Commonwealth Edison
One First National Plaza, Chicago, Illinois
Address Reply to: Post Office Box 767
Chicago, Illinois 60690

Responses to most of the NRC concerns on WCAP-9600 were previously transmitted to you via our C. Reed to D. Ross letter dated September 11, 1979. Transmitted herewith are the responses to the balance of the NRC concerns with the exception of concern D.26. In accordance with our letter (C. Reed to D. Ross dated August 23, 1979) with regard to our schedule for responses to the NRC concerns, the response to D.26 is still in preparation and will be submitted later this year subsequent to the responses to NUREG 0578.

SUBJECT: Report on Small Break Accidents for Westinghouse NSSS System

Figure B.1-2 Schematic of R&D Test Facility

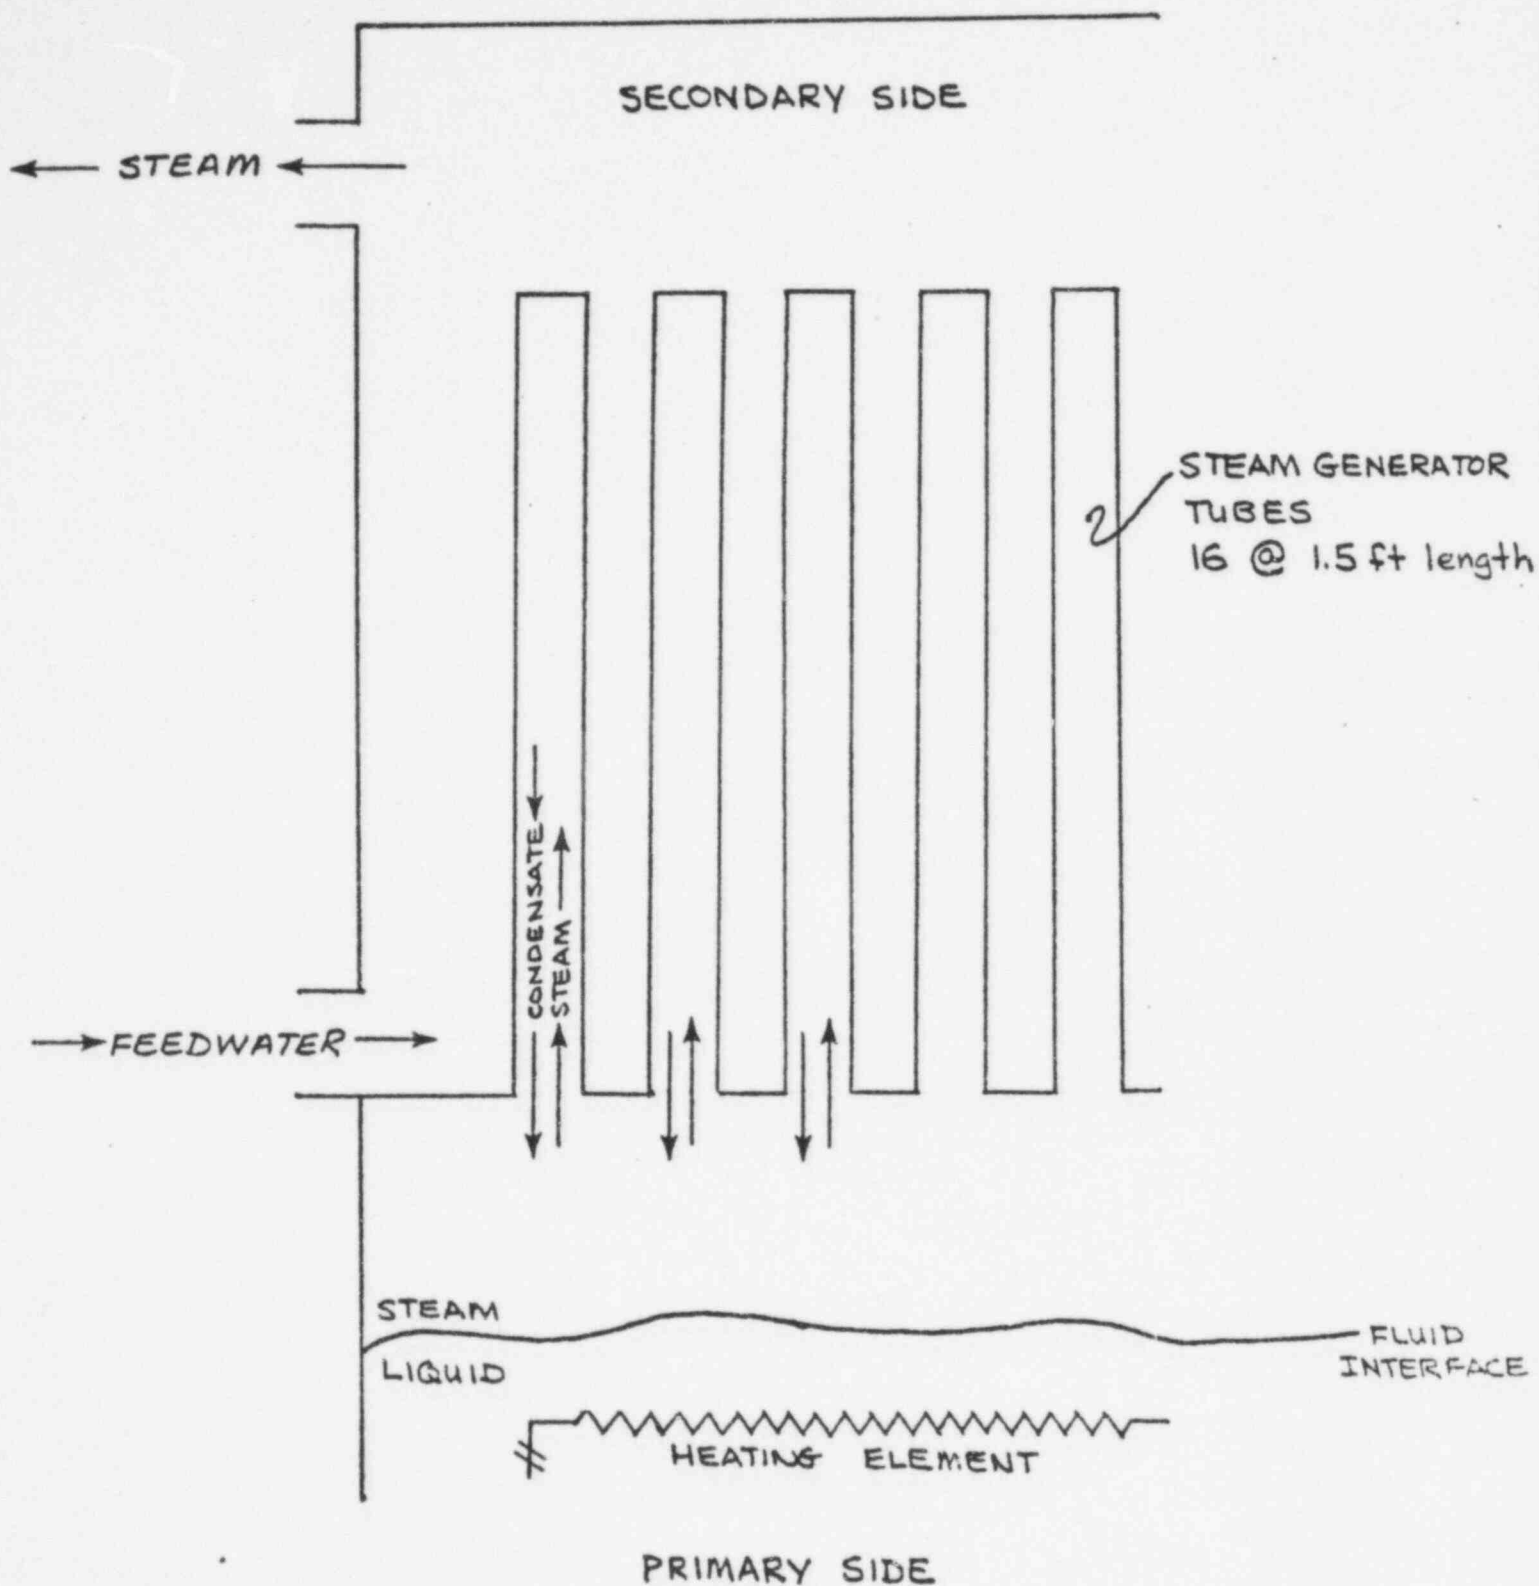
1. Discuss the applicability and application of the Roshenow Correlation. (In deriving the non-condensable heat transfer models, the assumption was made that this correlation predicts the liquid film conduction only.) This discussion should address the verification of the model, namely, the predictability of the model versus the non-condensable gas concentration/prototypic conditions and geometry.
2. Discuss the introduction of accumulator nitrogen for the case of a small pipe break larger than 2 inches in diameter.
3. Discuss how the reactor is brought to a cold shutdown condition following a small break LOCA in the primary system in which non-condensable gas accumulates in bends in the steam generator U-tubes.

Figure B.1-2 gives a schematic of the test facility. As this figure shows, steam enters the inside of the simulated steam generator tubes and is condensed. The condensate runs down the inside of the tubes and flows counter-currently with the steam. Tests were run for primary side steam fluxes ranging from []^{a,c} lbm/tube-hr with primary system pressures ranging from []^{a,c} psia, and secondary side pressures ranging from []^{a,c} psia. The tube steam flows correspond to those which could be generated by decay heats of approximately 1 to 6 percent in a typical four loop Westinghouse PWR. The range of test conditions cover those expected to occur following a small break LOCA. Therefore the test condensation heat transfer coefficients should be similar to those in a plant following a small break LOCA, with no non-condensibles present.

By comparing test heat transfer coefficients to those calculated for laminar film condensation (equation B.1-2), justification can be provided for this aspect of the model presented in reference 1.

Figure C.1-1

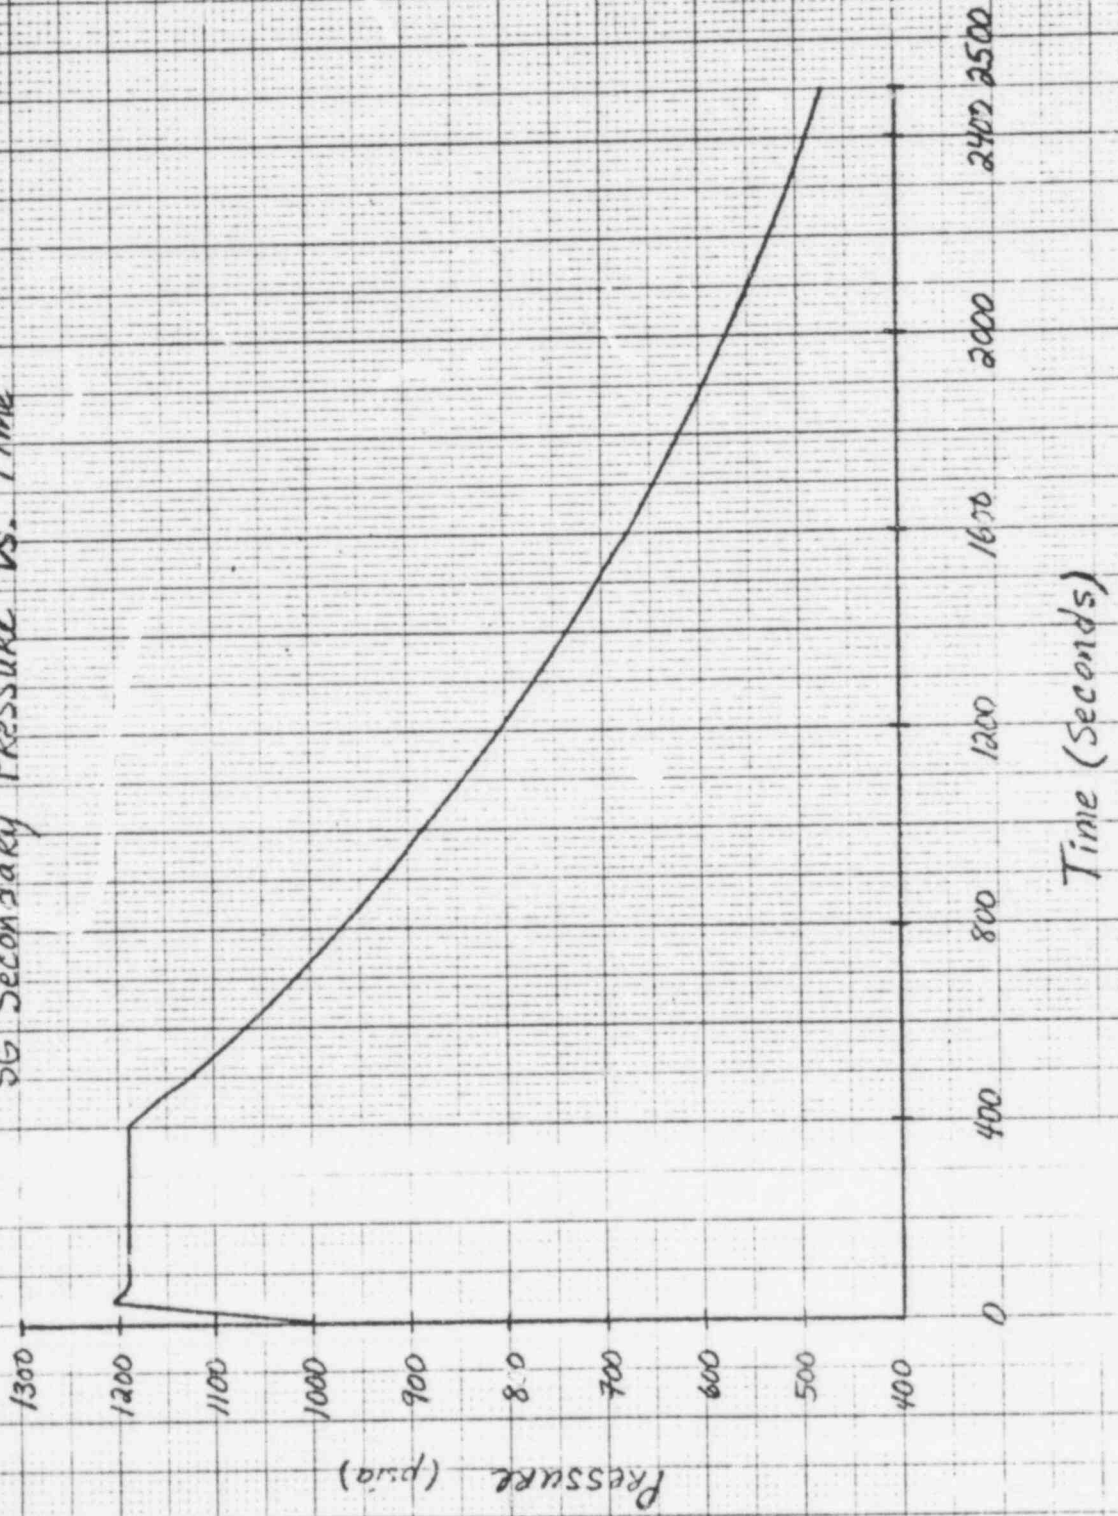
2. For the analysis of a 4.0-inch diameter pipe break in a 4-loop PWR, plots of certain steam generator parameters were provided for the broken loop. Provide plots of the same parameters for the steam generator in the intact loop.

Figures C.1-1 through C.1-15 present the plots for the intact loop steam generators for the 4.0-inch cold leg break reported as Case F in Section 3.1 of WCAP-9600.
